| JAYCEE PARK UPDATED CONCEPT

COMMITTEE OF THE WHOLE
OCTOBER 11, 2023

Jaycee Park Updated Concept

Updated Concept

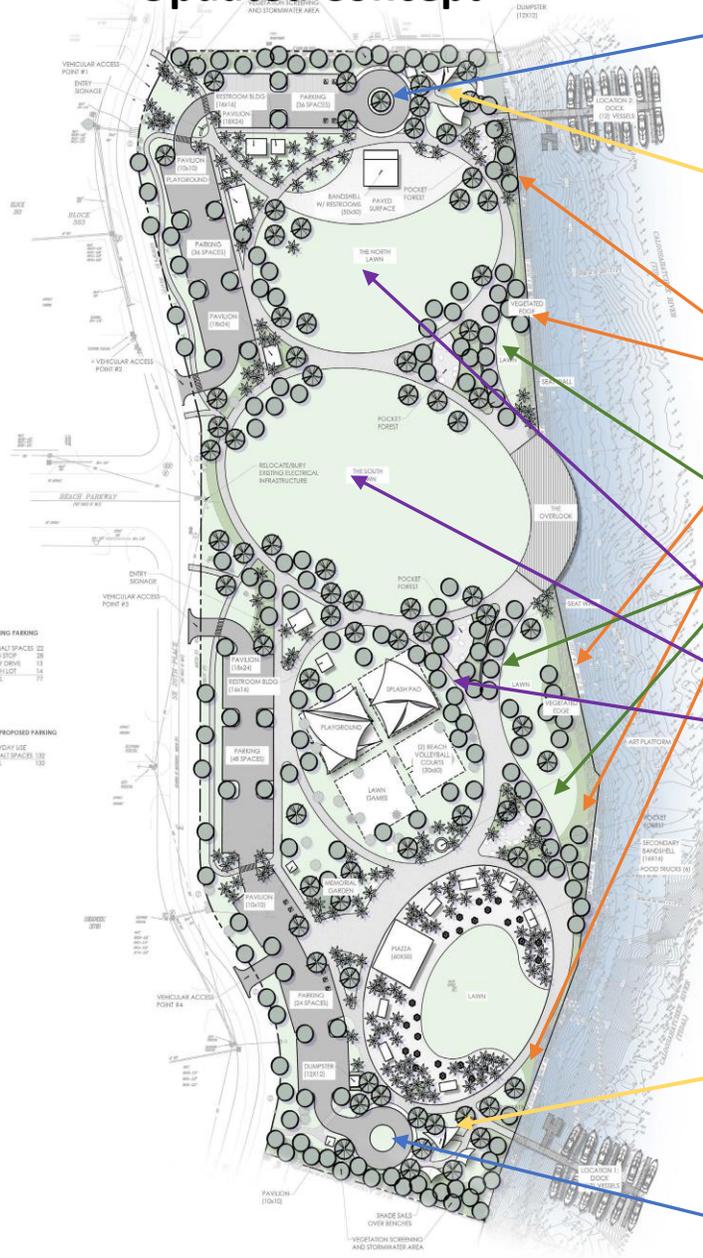
North Parking Lot Shifted West

Shade Sail Covered Seating

Shade Trees Along Shoreline

Shade Trees in Walking Path

More Shade Trees in Interior

Shade Sail Covered Seating

South Parking Lot Shifted West

A. Parking Spaces in Updated Concept: 132 (Original Concept: 156)

1. North Parking Lot Shifted to the West – Loss of 12 Parking Spaces
2. South Parking Lot Shifted to the West – Loss of 12 Parking Spaces
3. **Note:** Current Parking Spaces – 77

1. ADA Parking on East End of North & South Parking Lots with Turnaround / Drop Off Point for Better Access to Shade Sail Seating Areas or General Pathway

1. Shade Trees added to Shoreline, Pathways and Park Interior
 - i. # New Trees in Original Concept – 305 / # New Trees in Updated Concept – **425**
2. Maintain the “View” upon Entry from Beach Parkway

1. Shade Sail Covered Seating (benches) Added to North/South Ends of Park

Dog Cooling Options Concept

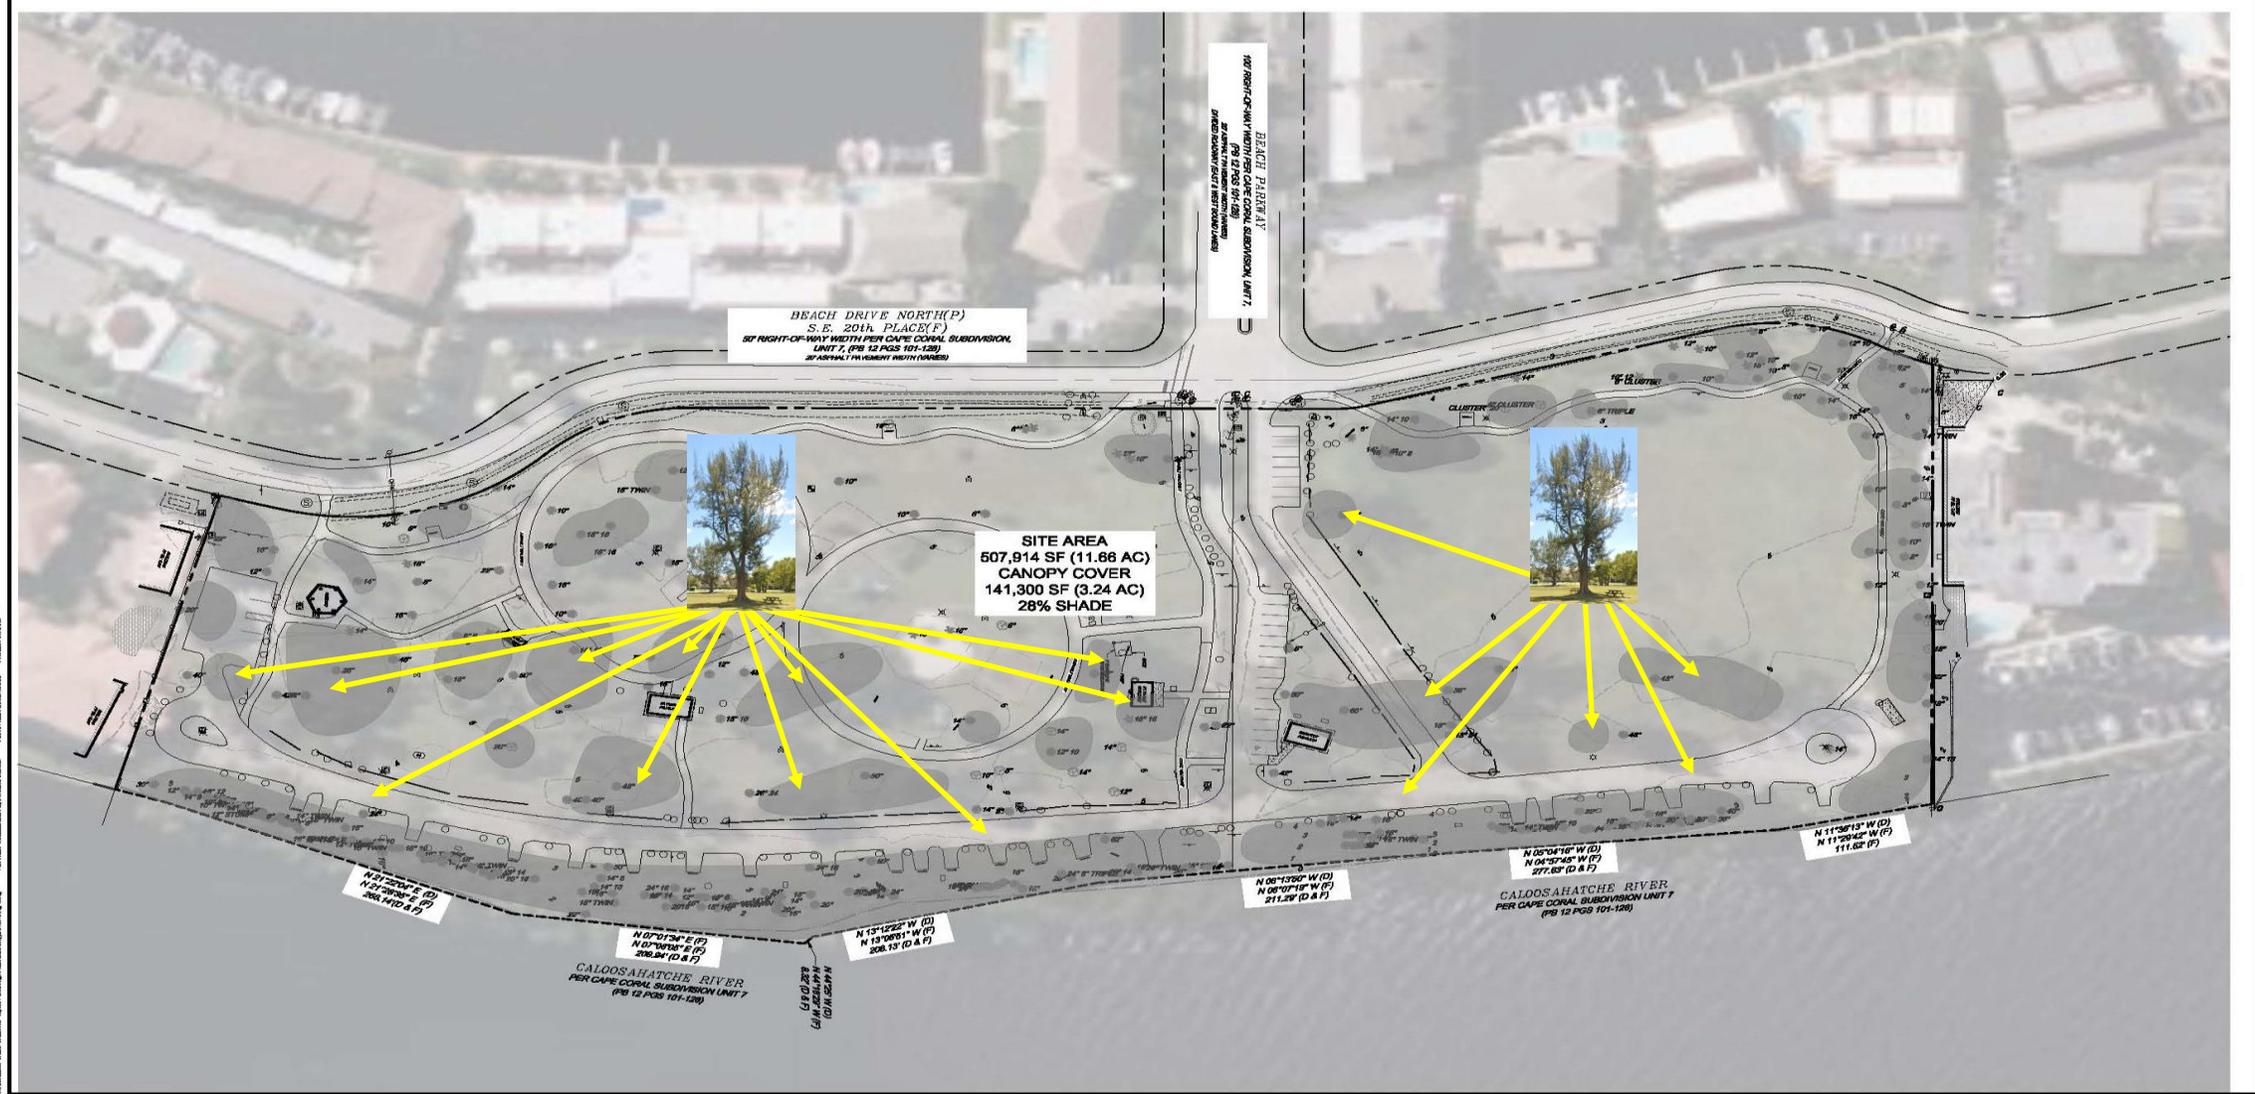
Dog Accessible Drinking Bowl

Dog Cooling/Misting Station

1. Bike Racks Available, Grills at Specific Pavilions, EV Charging Station (TBD), Dog Cooling Stations (including misting and drinking fountains)
